PLANNING AND DEVELOPMENT SERVICES STAFF REPORT

For Planning Commission Meeting of March 18, 2014

SUBJECT: **South State Street Shell Gas Station/Drive-Thru Restaurant Site Plan for City Council Approval
(2991 S. State Street)
File No. SP13-058**

LS-1

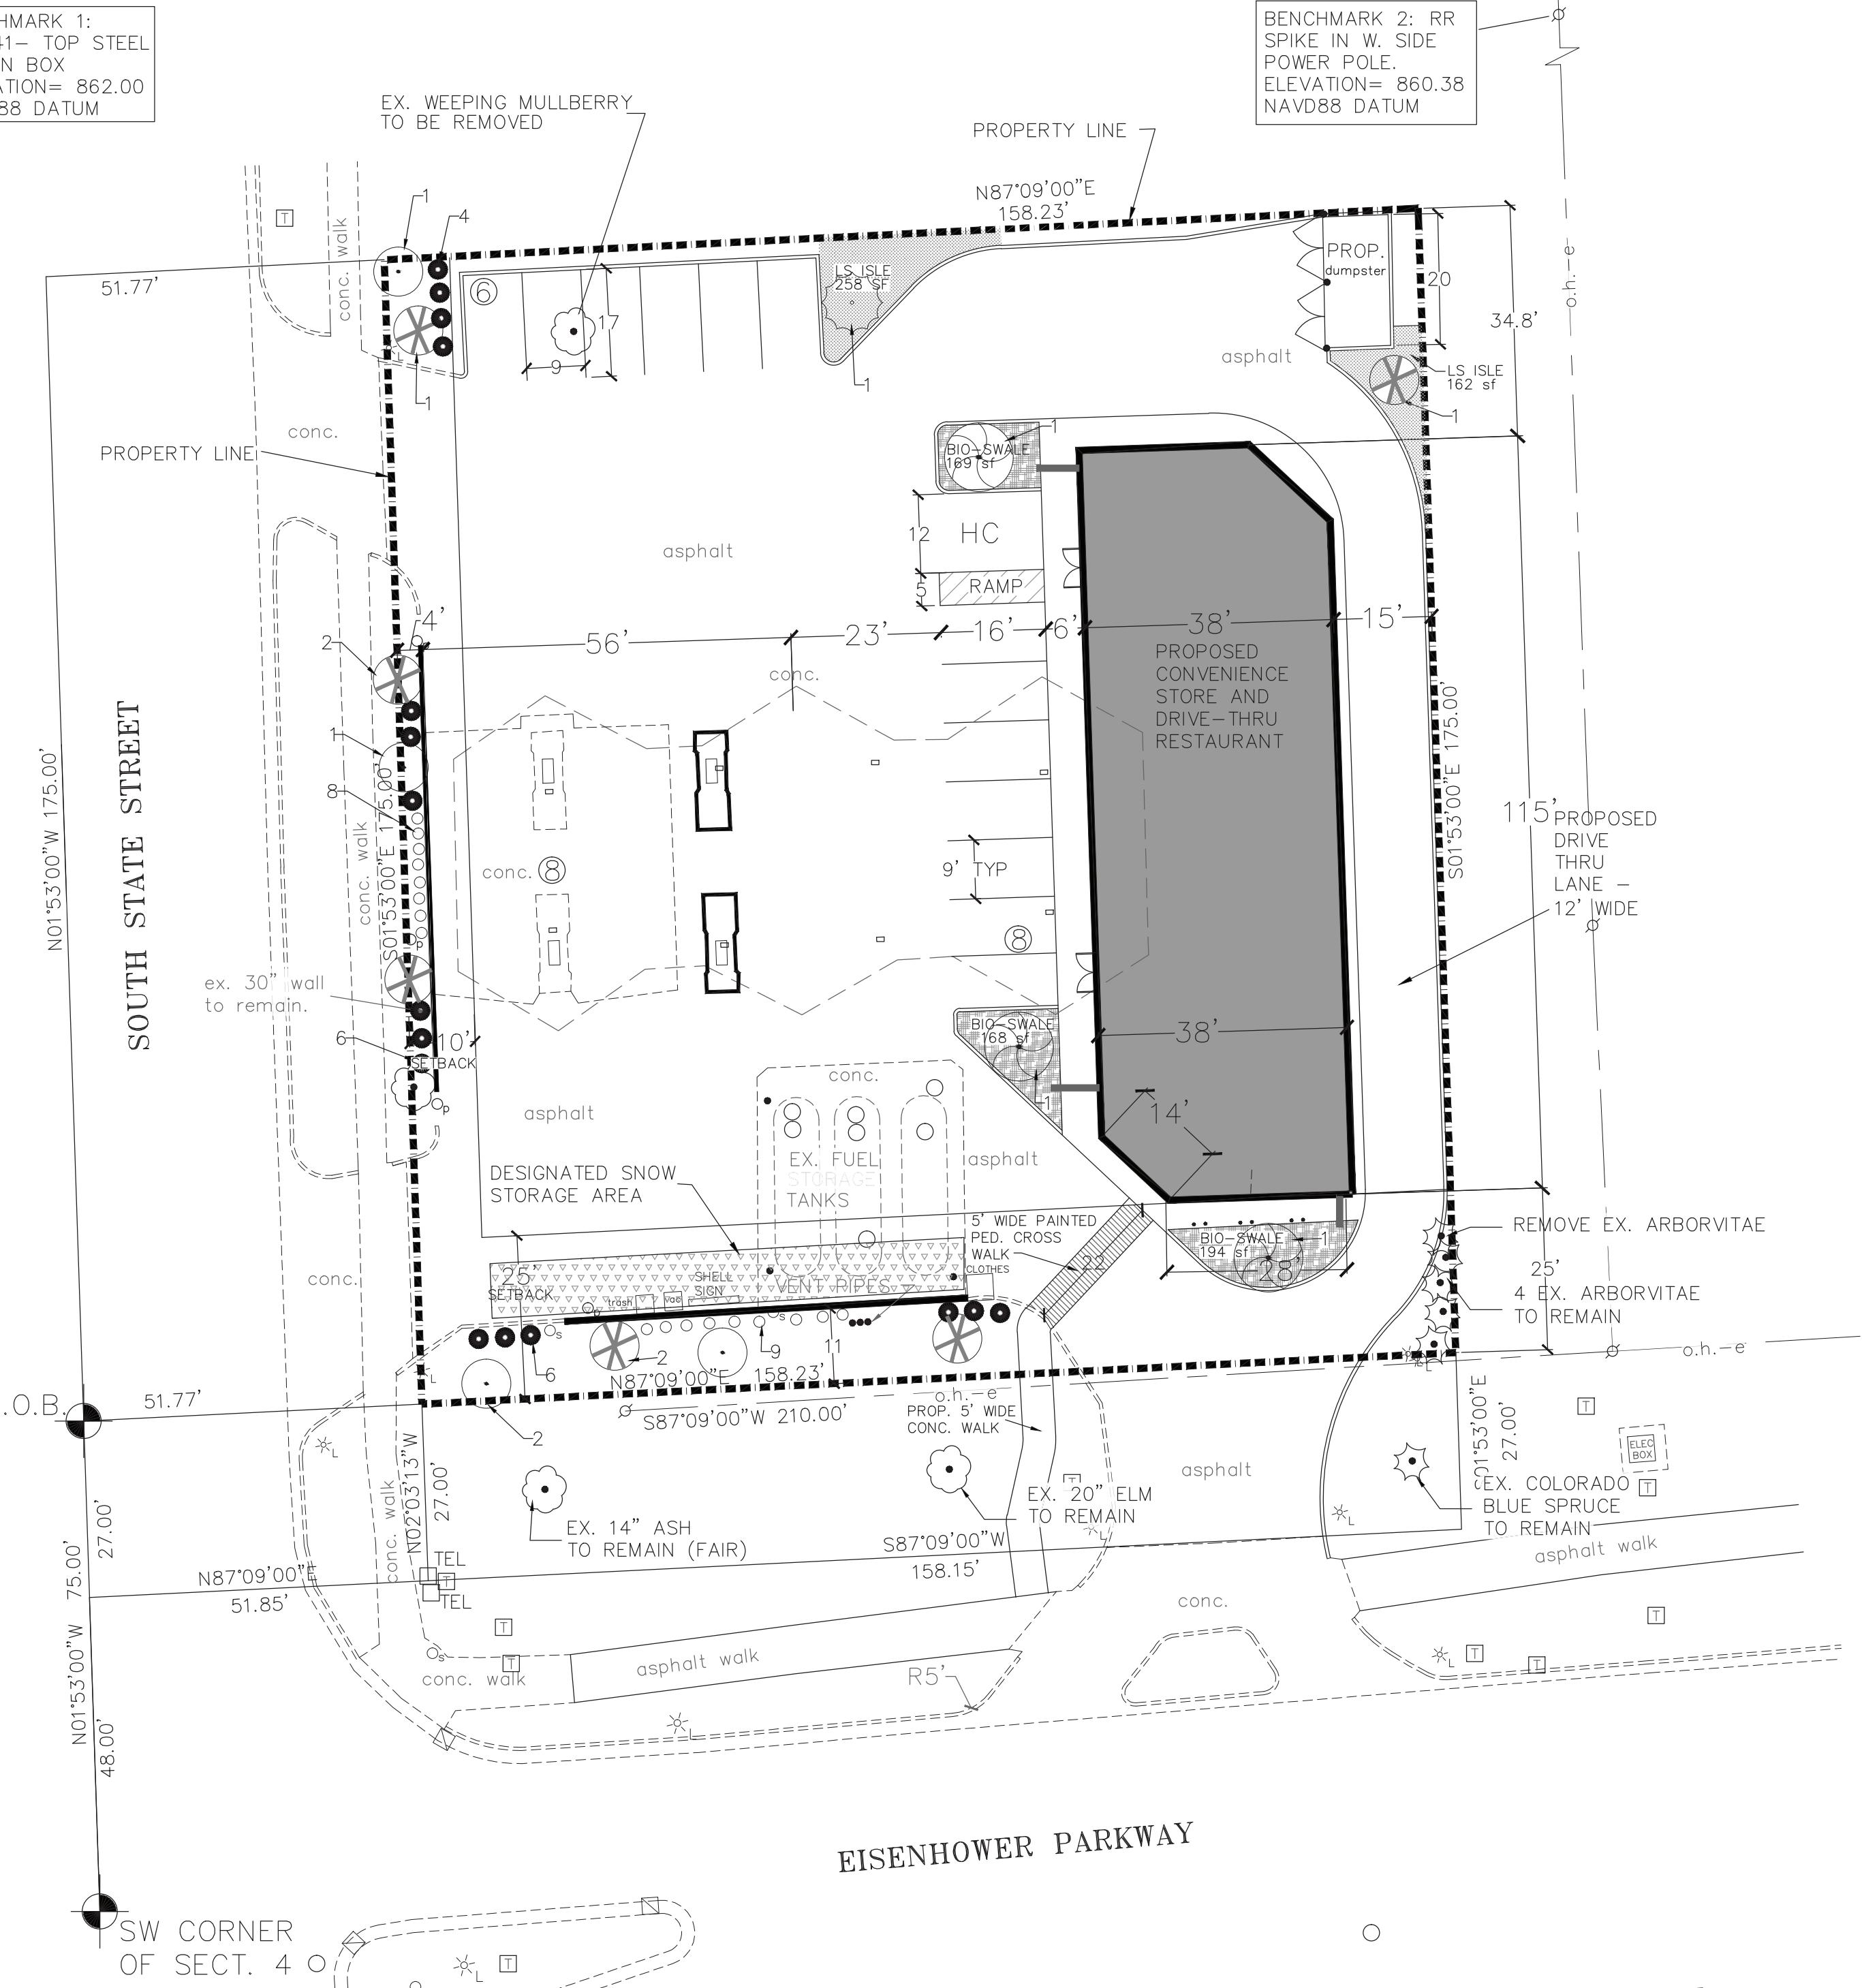
The existing 4-foot wide right-of-way landscape buffer strip fronting S. State Street contains a 30-inch high screening wall and landscaping. The petitioner is requesting approval of a landscape modification to maintain the reduced width of the buffer, allowing for continued use of the two gas pump islands located on the western portion of this site. In exchange for this reduced buffer width, additional landscaping is proposed within the S. State Street and E. Eisenhower Parkway buffers to further screen the vehicular use area.

A minimum 10-foot wide right of way buffer strip is required to screen from the vehicular use area. Currently the site has a 4-foot wide buffer strip, with a 30-inch screening wall and landscaping. This proposal adds landscaping in exchange for the 6-foot reduction in buffer width. Widening the buffer width would eliminate two existing pumps and their associated parking spaces.

The intent of the ordinance is to provide a screening buffer between the parking lot and the public right-of-way. A reduced buffer strip to 4-feet wide, along with additional landscaping and a 30-inch high wall screens the vehicular use area from S. State Street.

Systems Planning – Forestry – Staff supports the landscape modification submitted by the petitioner to maintain the right of way buffer width of 4 feet along S. State Street due to a loss of required parking spaces if the landscape requirement were met. The petitioner is proposing more landscaping in the right-of-way buffers along both Eisenhower Parkway and S. State Street than is required.

Staff research shows the current right-of-way landscape buffer along State Street was originally site planned for a 5 foot width, which was a permitted exception for gas stations in the Landscape Ordinance in effect at the time. It is likely the planned five foot width was reduced to four feet sometime later in the recording of the new right-of-way. Staff supports the landscape modification request to reduce the buffer strip width from 10 feet to 4 feet. Increasing the buffer width to 10 feet would require the petitioner to relocate the two associated parking spaces and make the existing pump islands less accessible. The petitioner proposes additional landscaping to screen the vehicular use area and site from the public right-of-way in exchange for this reduction in width.

LANDSCAPE MODIFICATION REQUESTED ALONG STATE ST. FRONTRAGE:
PER CHAPTER 62, 5:608 (c) (ii) AND (c)(vii) - STRICT ADHERENCE OF 5:602(1)(a) (LANDSCAPE BUFFER STRIP) WOULD RESULT IN LOSS OF PARKING REQUIRED PARKING SPACES AND IS AN EXISTING NONCONFORMING CONDITION IN A PREVIOUSLY APPROVED SITE PLAN. AN EXISTING 30' WALL IS LOCATED 4' FROM THE STATE ST. ROW AND NEW SHRUBS ON THE STREET SIDE ARE PROPOSED. THIS MEETS 5:602(1)(d) SPECIFICALLY FOR GASOLINE STATIONS.
